- **ALTERNATOR—REPETITIVE DRIVE BELT FAILURES—VEHICLES BUILT FROM 2/11/91 TO 1/28/92**
- **BATTERY—DISCHARGED—CHARGE INDICATOR LAMP LIT—VEHICLES BUILT FROM 2/11/91 TO 1/28/92**
- **ACCESSORY DRIVE BELT—1.6L—REPETITIVE FAILURES—VEHICLES BUILT FROM 2/11/91 TO 1/28/92**

**Article No.
92-6-10**

MERCURY: 1991-1992 CAPRI

Figure 1 - Article 92-6-10

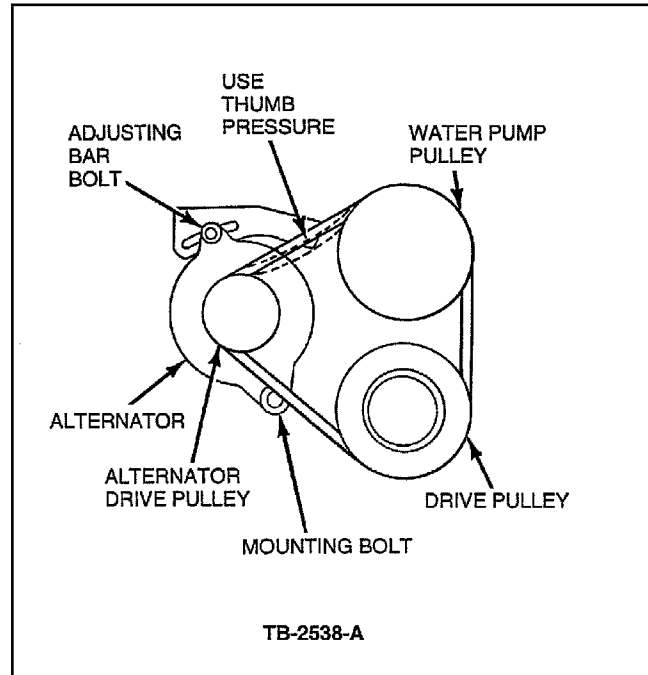
APPLY MODERATE THUMB PRESSURE (ABOUT 22 LBS., 10 KG) MIDWAY BETWEEN THE ALTERNATOR DRIVE PULLEY AND THE WATER PUMP PULLEY, FIGURE 1. CHECK THE DEFLECTION PER THE FOLLOWING ACCESSORY DRIVE BELT DEFLECTION CHART

ACCESSORY DRIVE BELT DEFLECTION CHART	
ACCESSORY DRIVE BELT	NEW BELT DEFLECTION
Alternator Drive Belt	0.25-0.35" (6-9mm)
